**ADDENDUM NO. 1**

**MLK ELEMENTARY SCHOOL  
TRANSITIONAL KINDERGARTEN  
BAKERSFIELD CITY SCHOOL DISTRICT**

**Project No.: 5593  
DSA File No. 15-6  
DSA App No. 03-123900  
December 20, 2024**

Sheet No.:  
**A5.01**

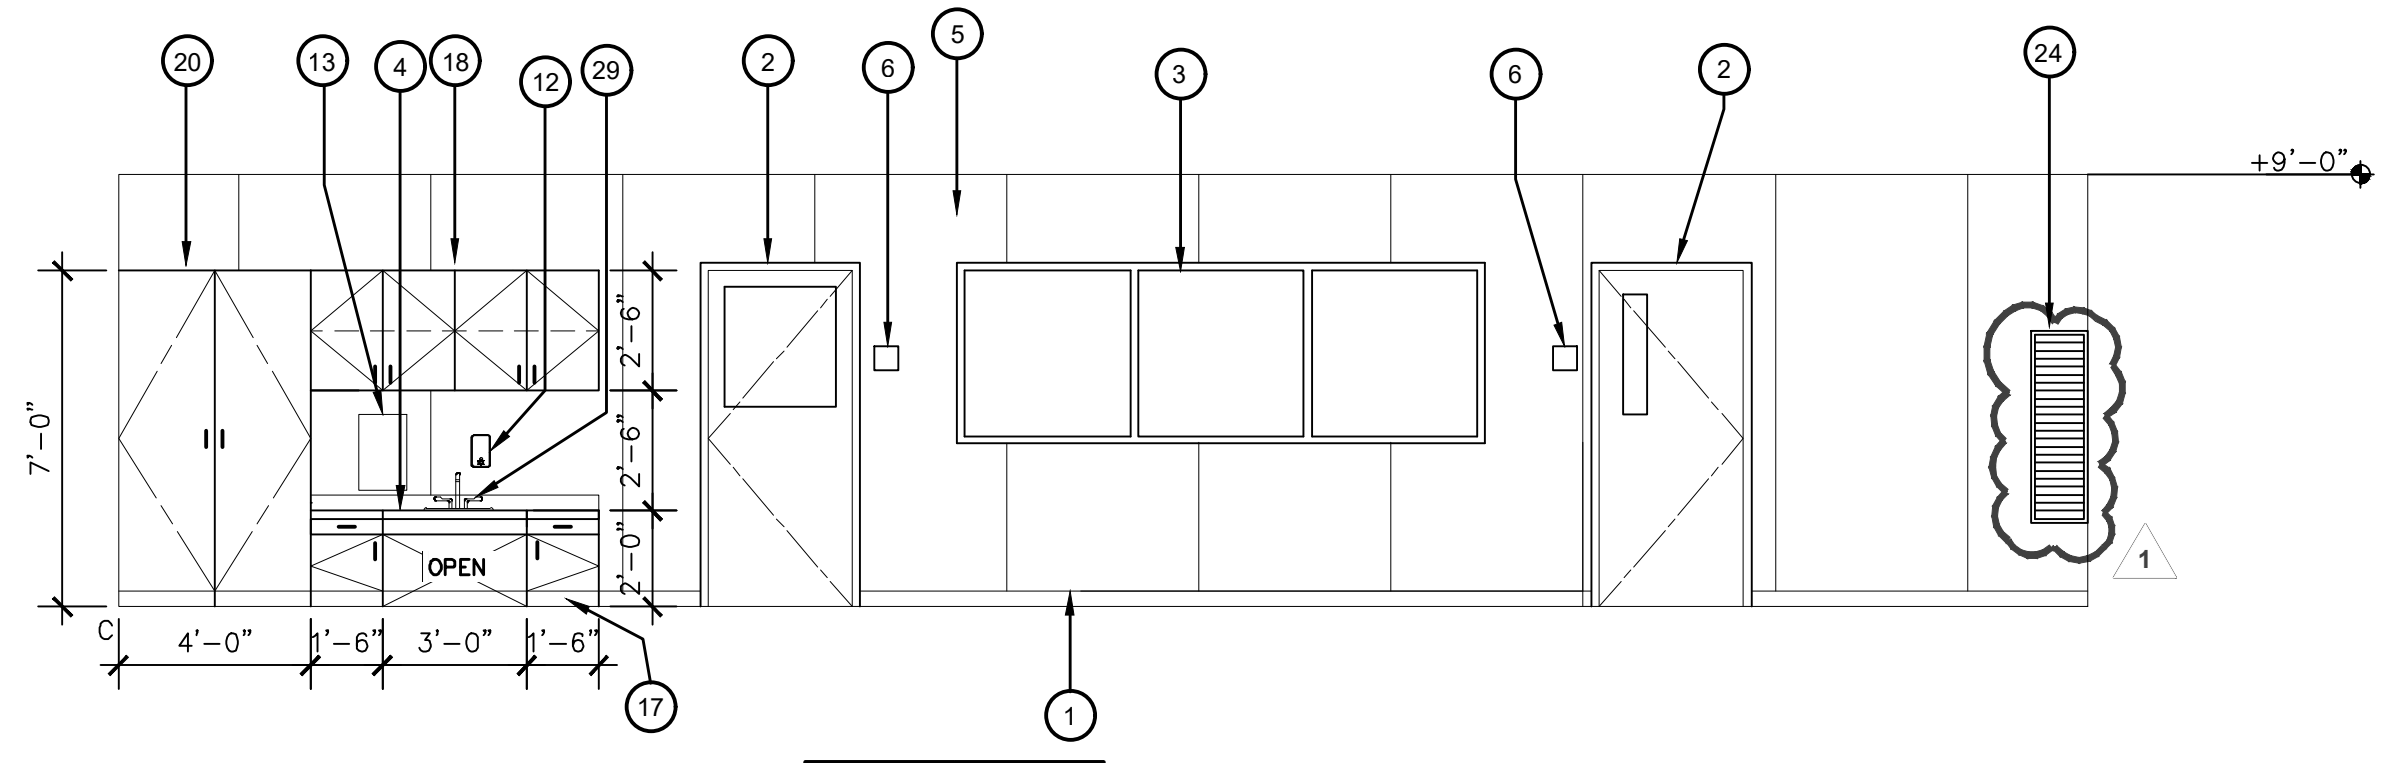
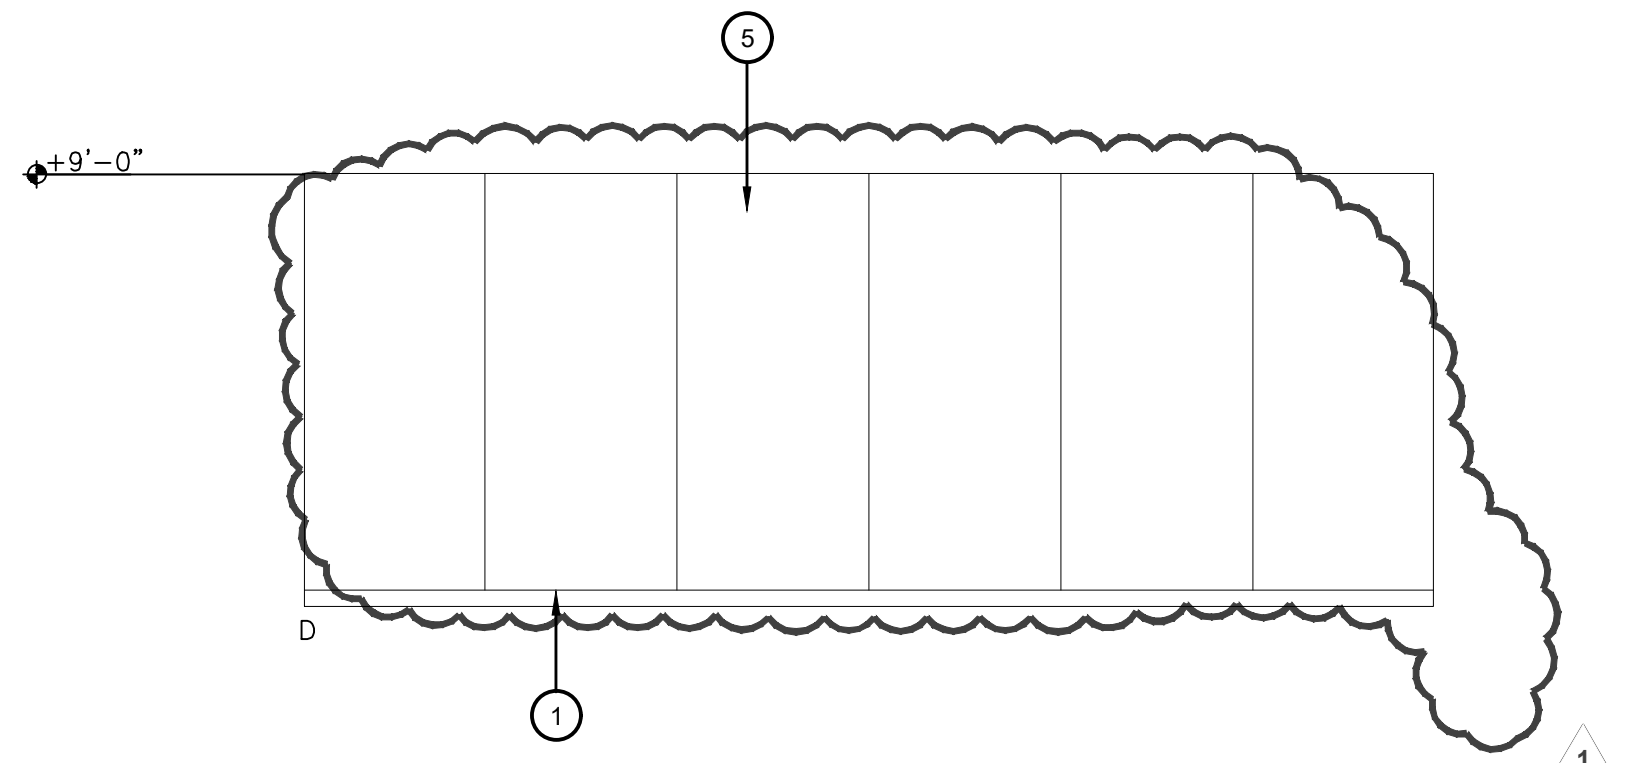
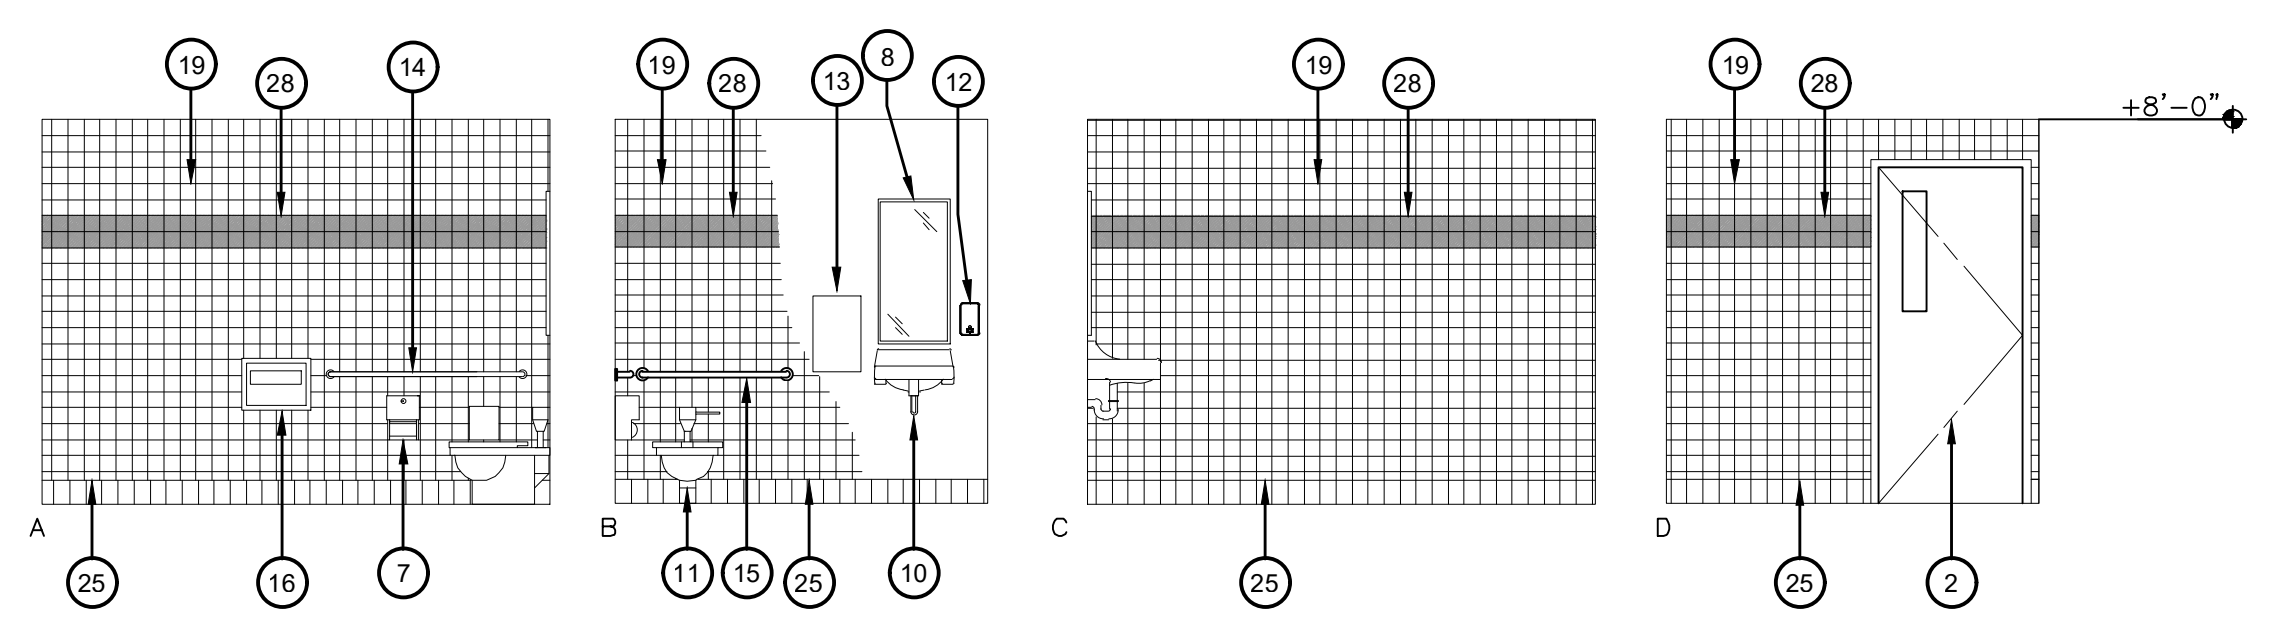
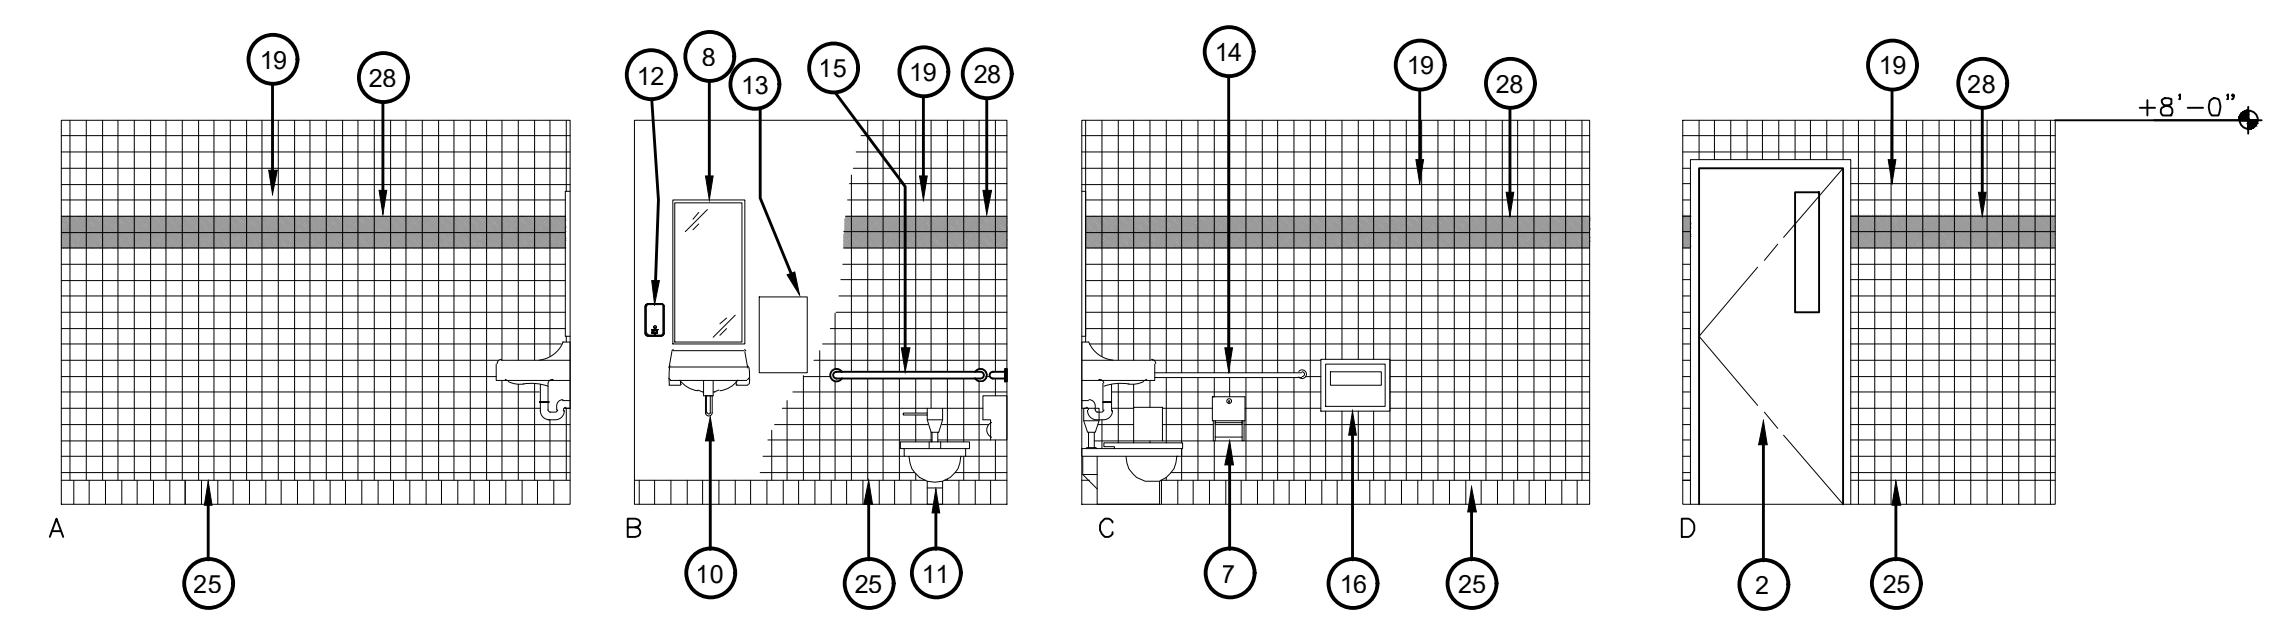
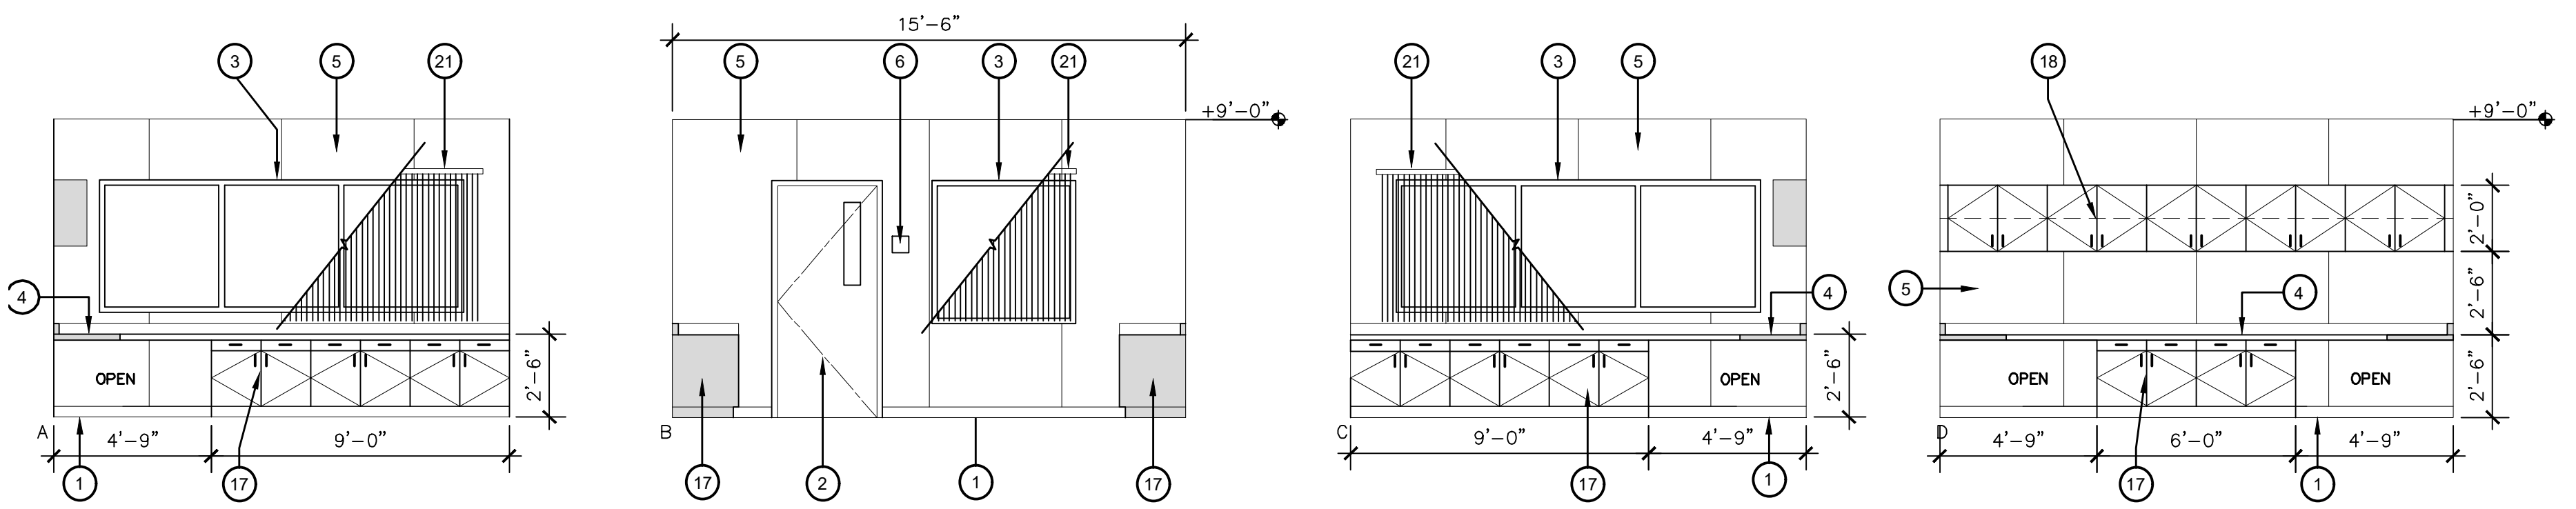
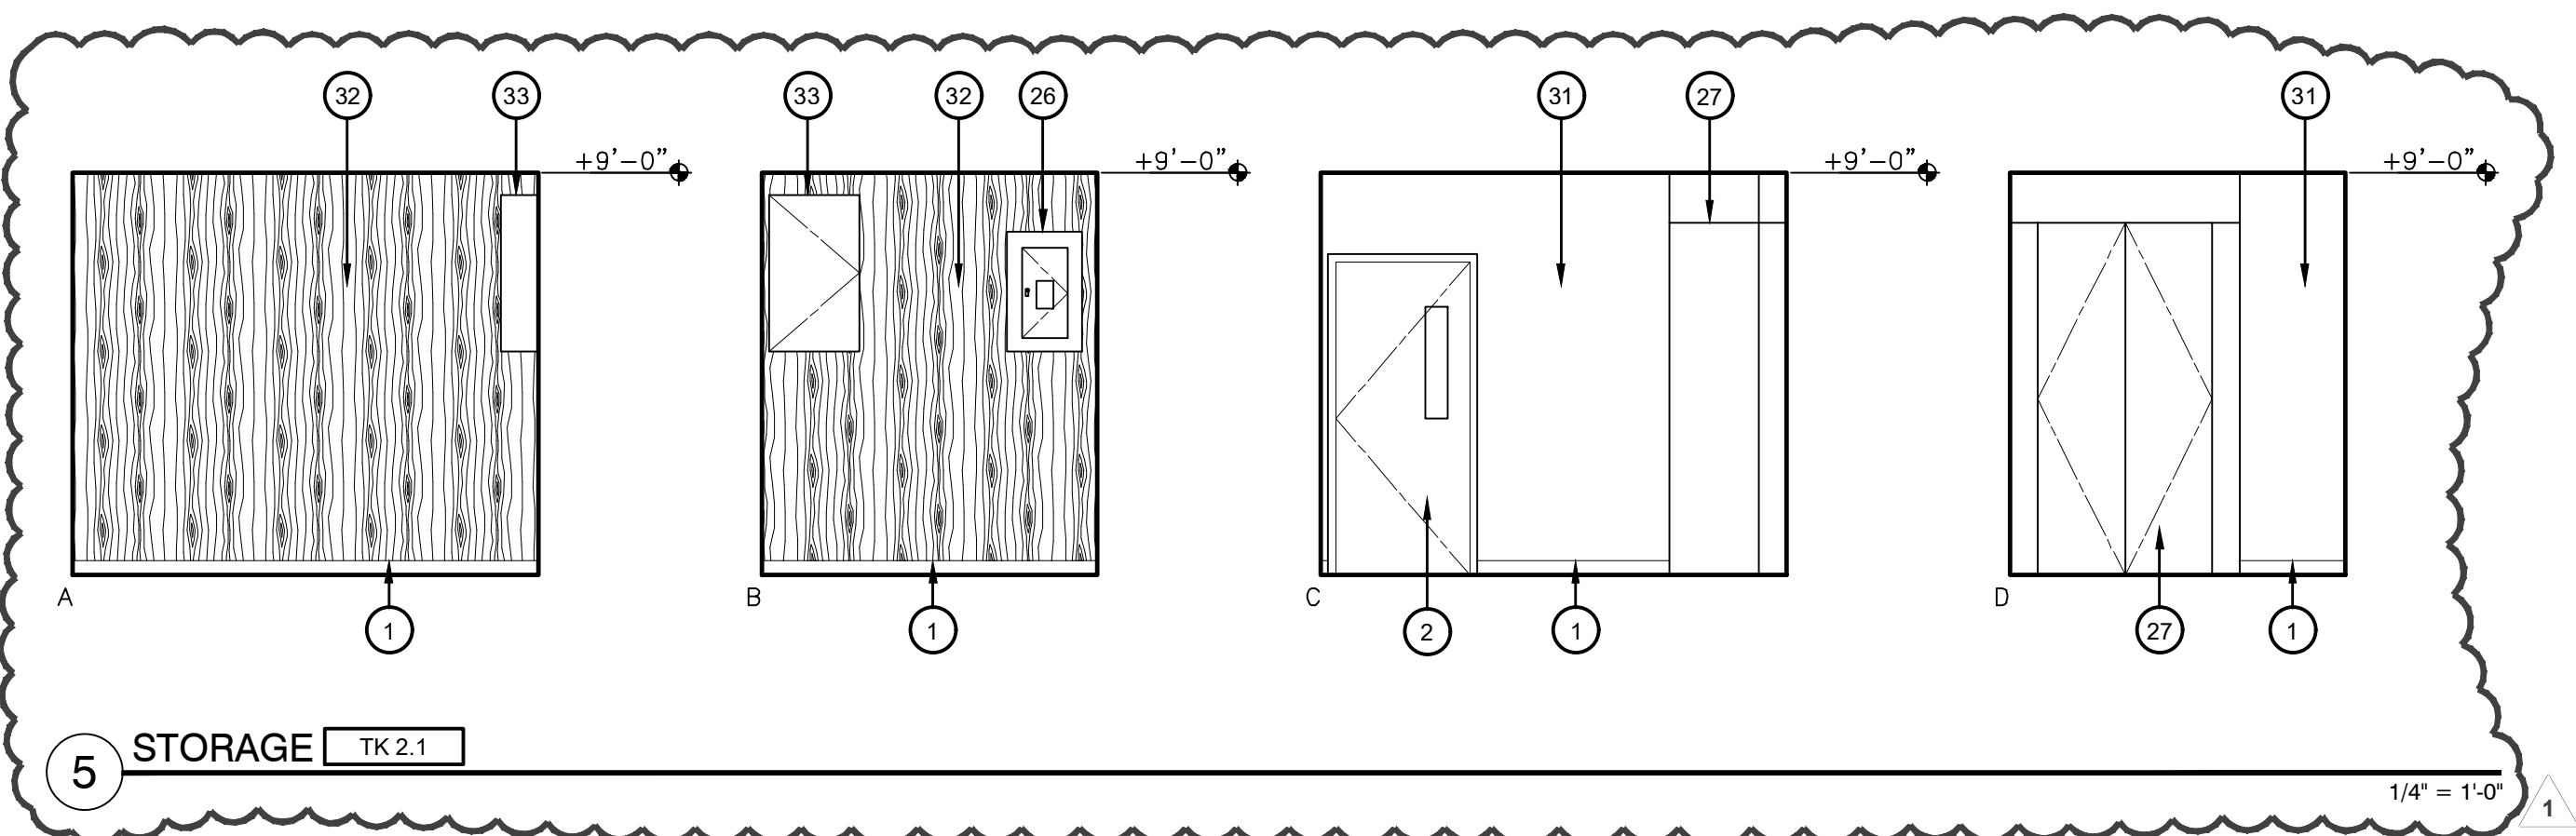
**1-11 DRAWING, SHEET A5.01 – INTERIOR ELEVATIONS:** Note the following changes (See A5.01 addendum 1 drawings):

1. Elevation “B” and “D” TK 1 and TK2.:
2. Markerboards and smartboard have been modified
3. Add elevations to storage room TK2.1
